NEW MEXICO DESIGN CENTER

DRB-97-270

DRAWING INDEX - D.R.B. SUBMITTAL SET

SITE PLAN
DR.B. SUBMITTAL PLAN SET

1 Site Plan
 1"=20'-0"

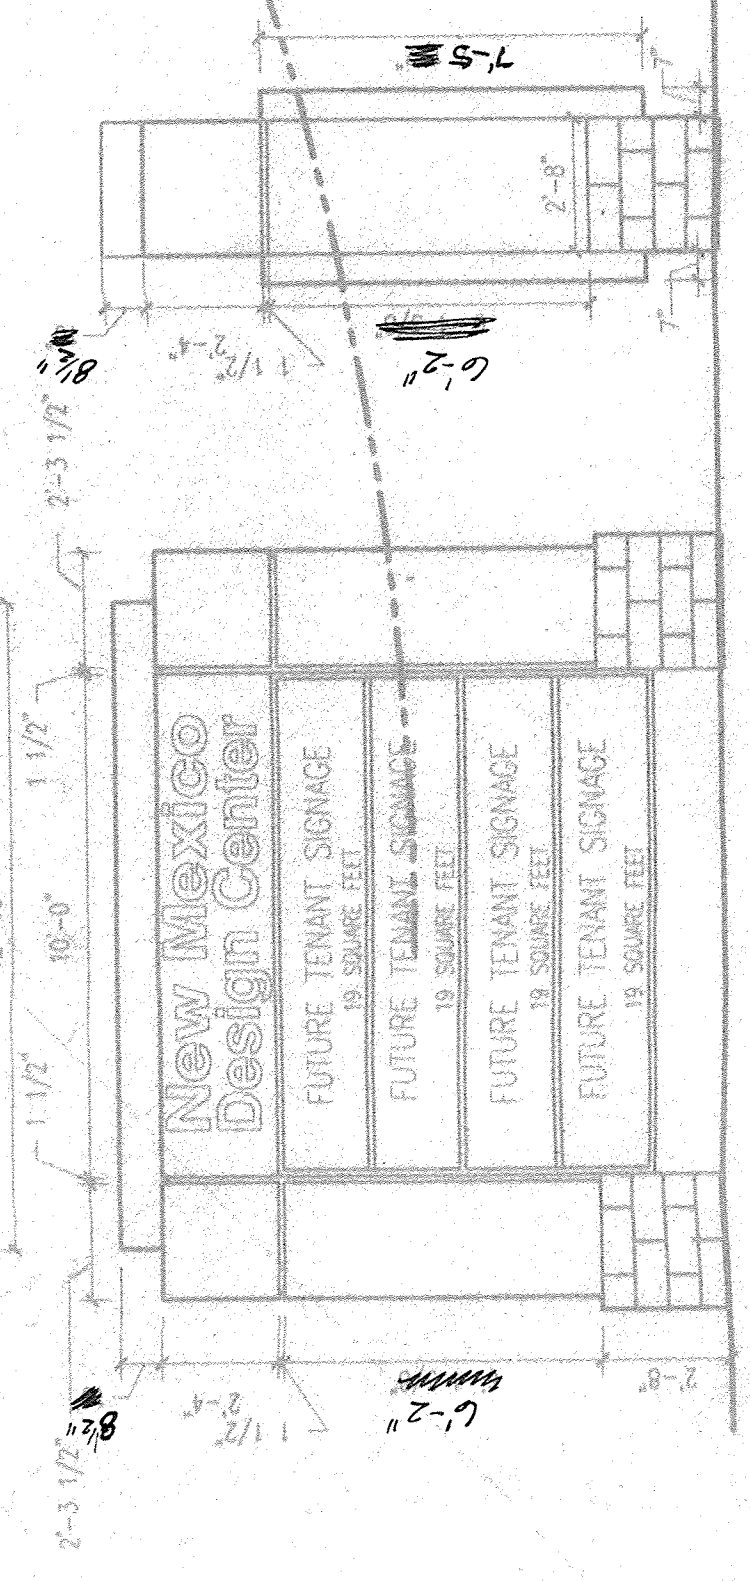
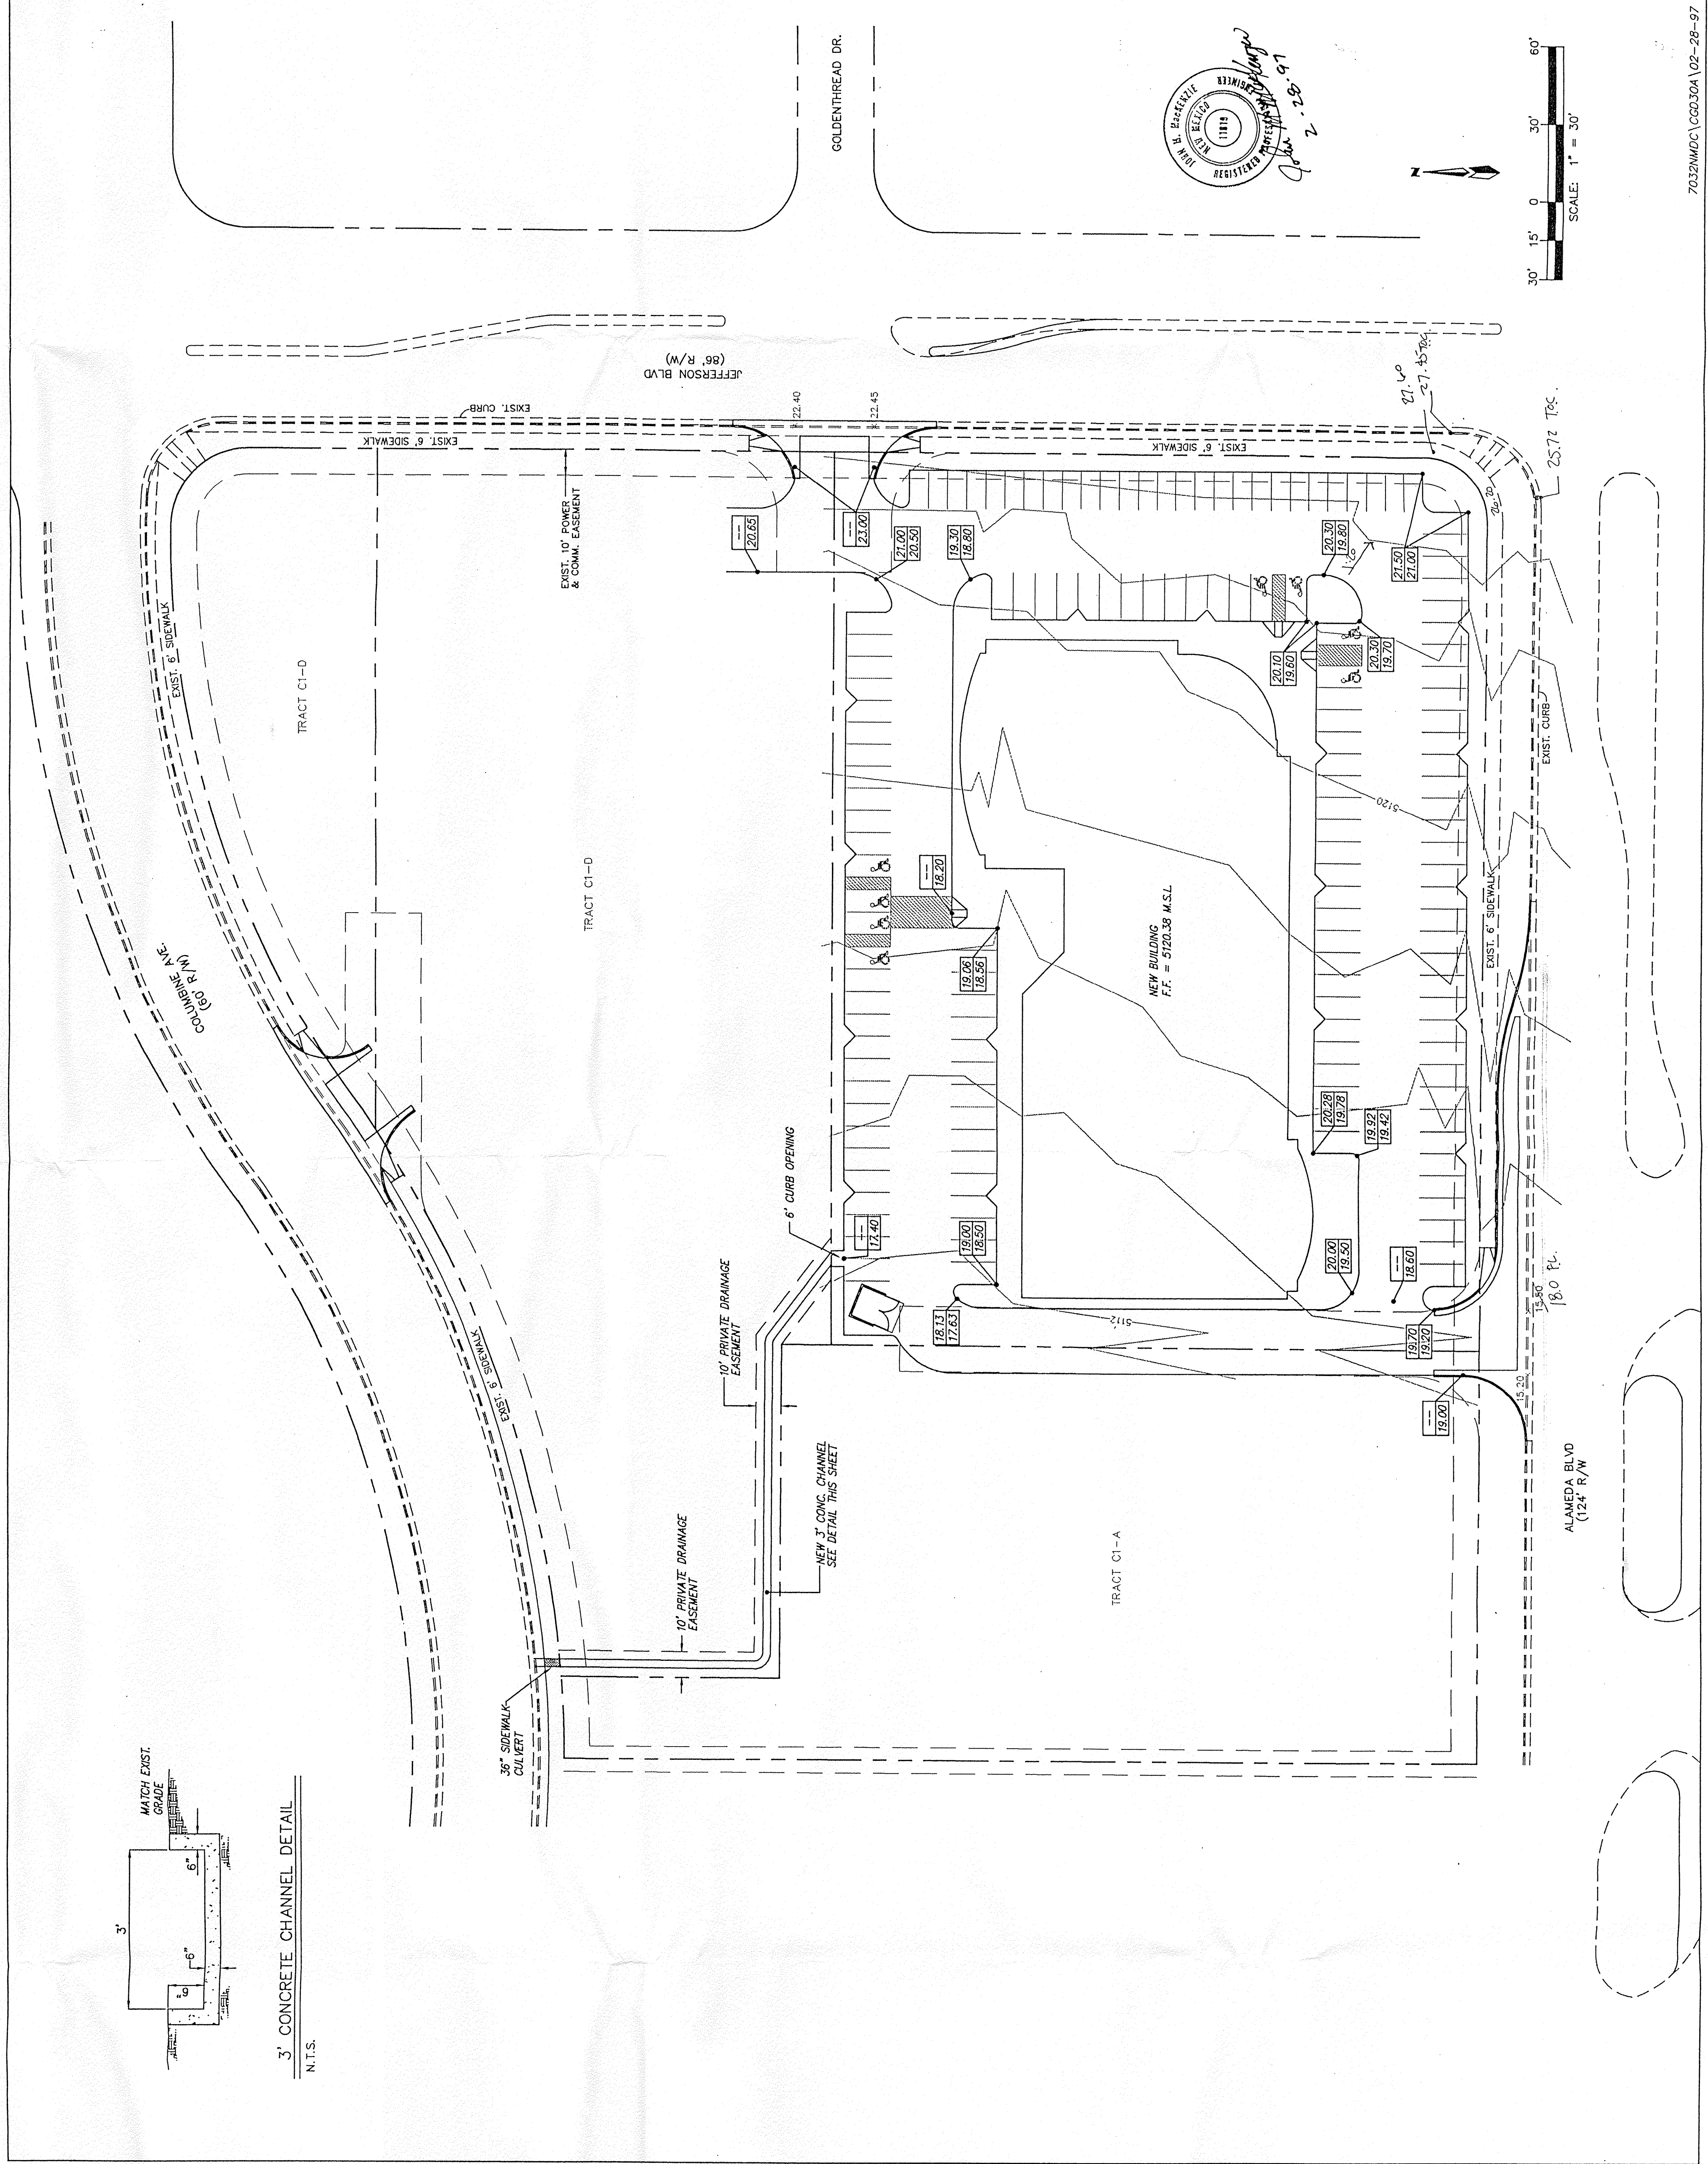
DRIVEWAY DESIGN IS CONCEPTUAL ONLY. DETAILED DRIVEWAY PLAN WILL BE REQUIRED TO MEET DESIGN CRITERIA OF NMS&TD (INCL. ACCOMMODATING WB-50 VEHICLE MOVEMENTS). DRIVEWAY IS APPROVED AS A RIGHT-TURN-IN, RIGHT-TURN-OUT, LEFT-TURN-IN ONLY DRIVEWAY IN ACCORD W/ KATHERINE TRUJILLO'S APPROVAL LETTER, DATED MARCH 10TH, 1998.

9702-A3B

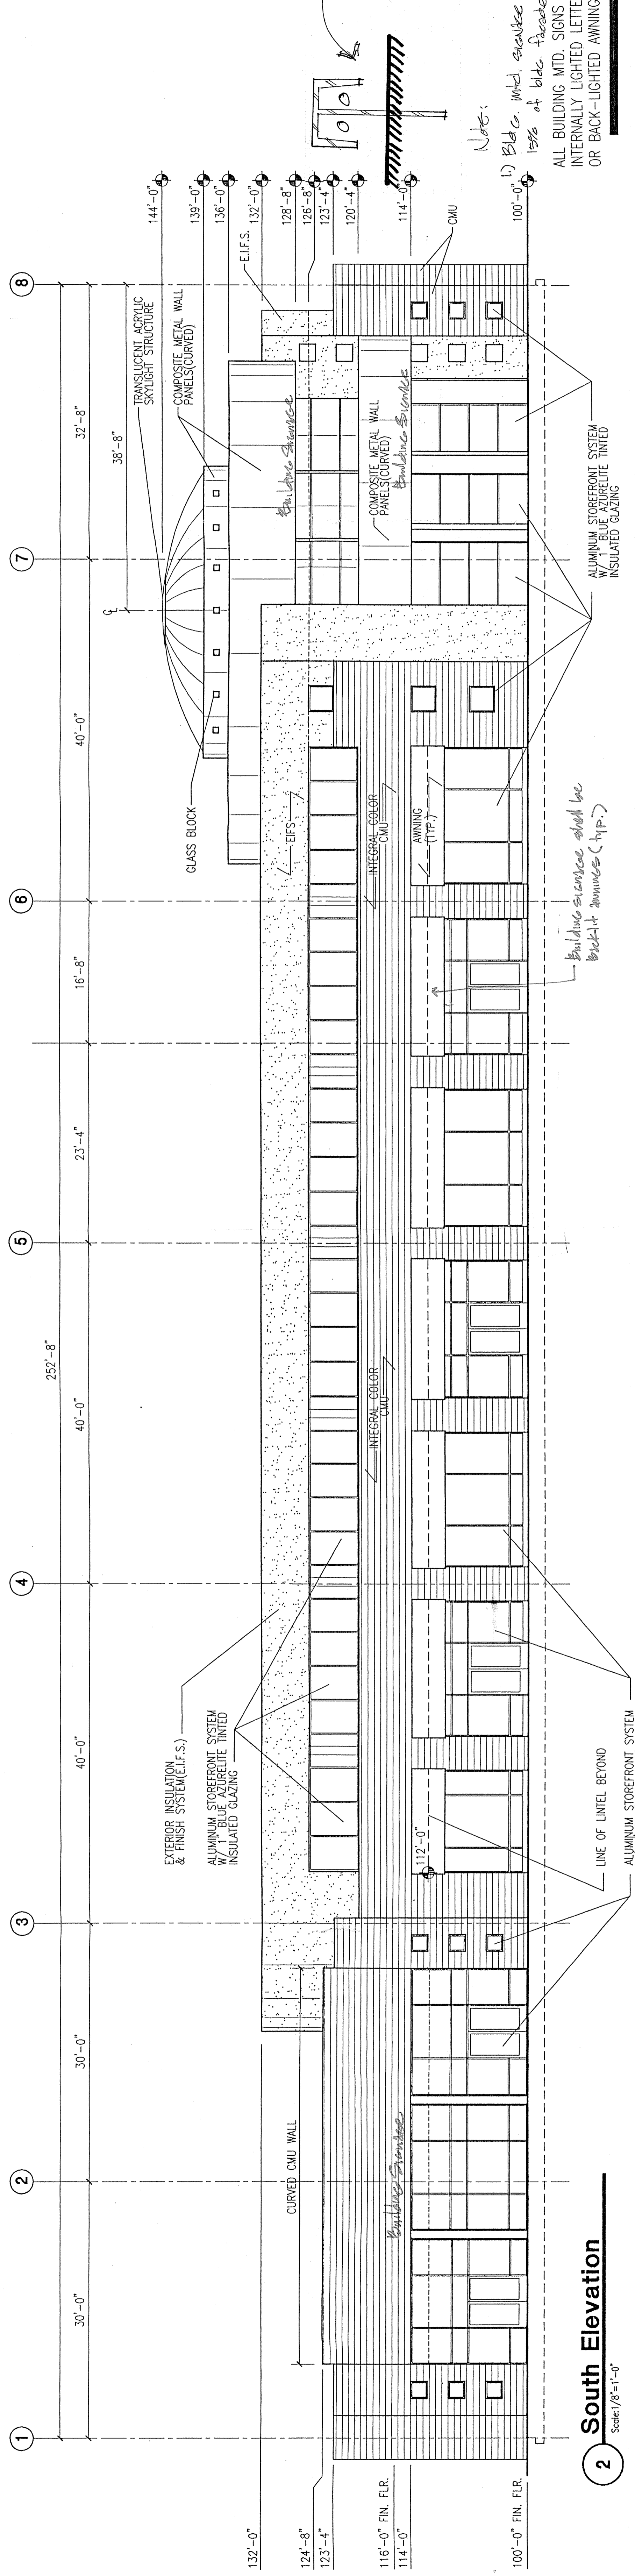
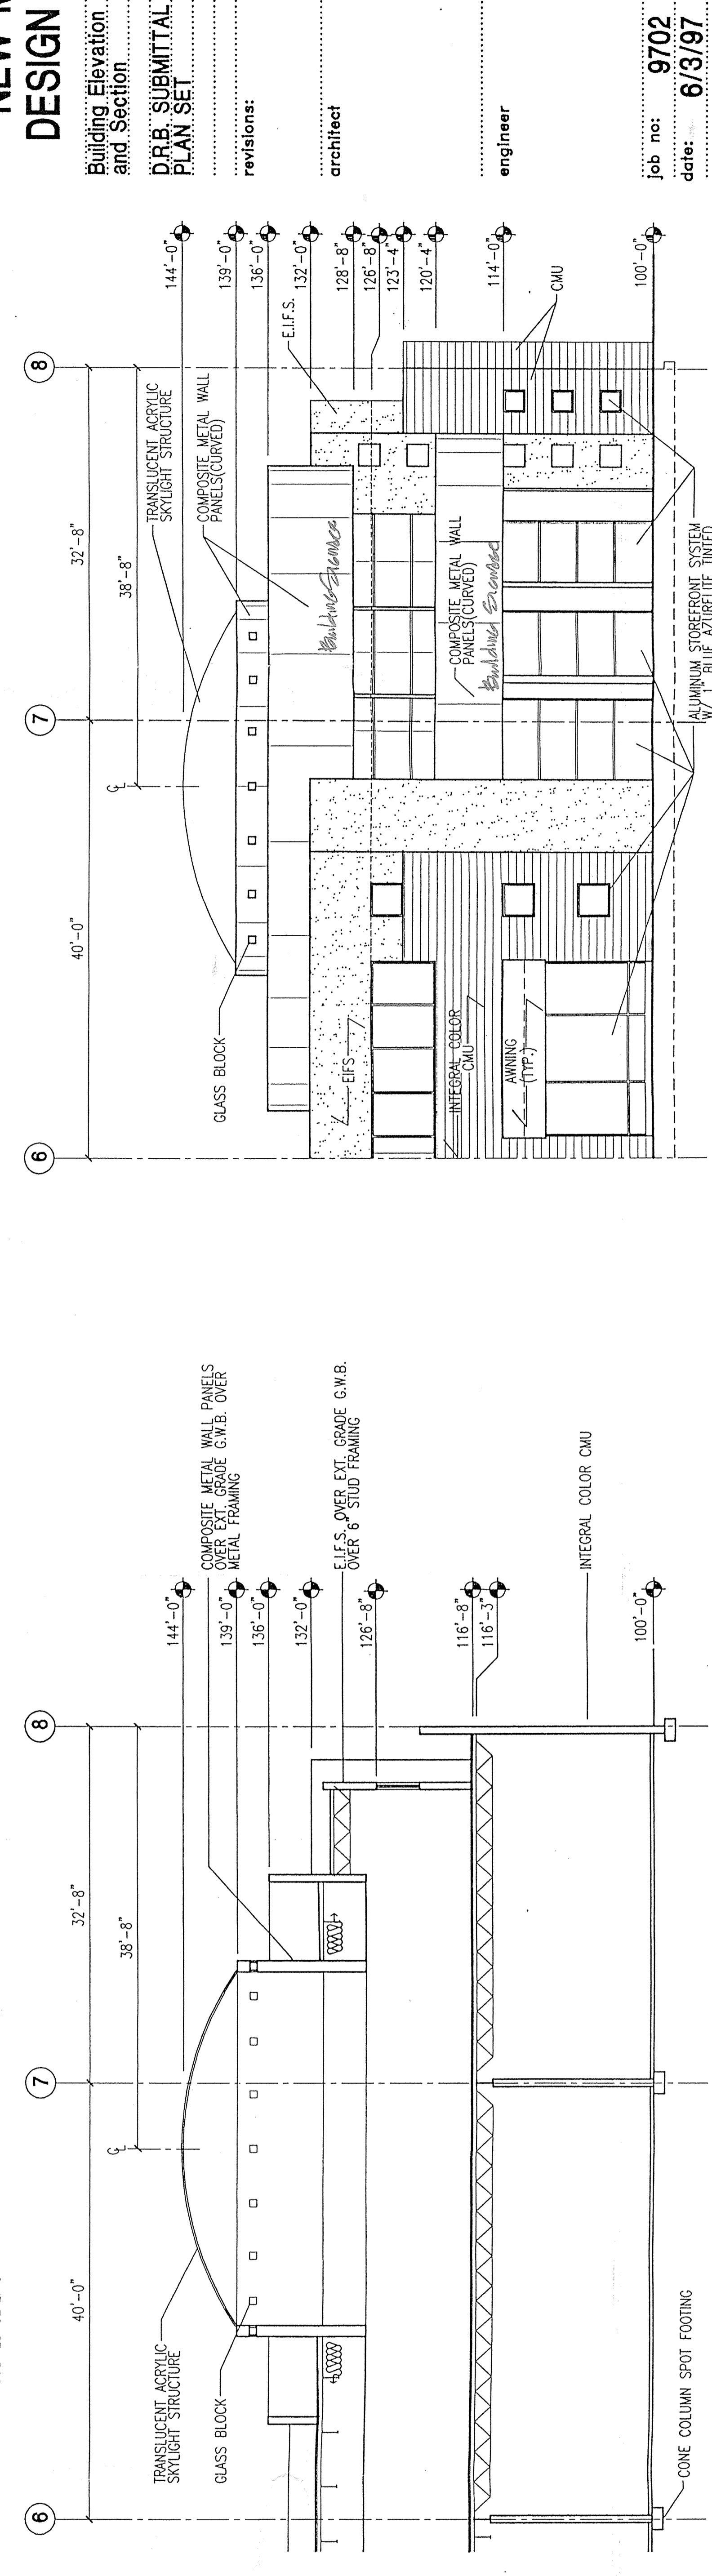
Notes:
 1) Bldg. mtd. signs not to exceed 15% of bldg. facade area
 ALL BUILDING MTD. SIGNS SHALL BE INDIVIDUALLY LIGHTED WITH 24" HIGH MAX. OR BACK-LIGHTED AWININGS
 Section thru bldg. with signage letters.

Building signage shall be backlit awnings (TYP.)
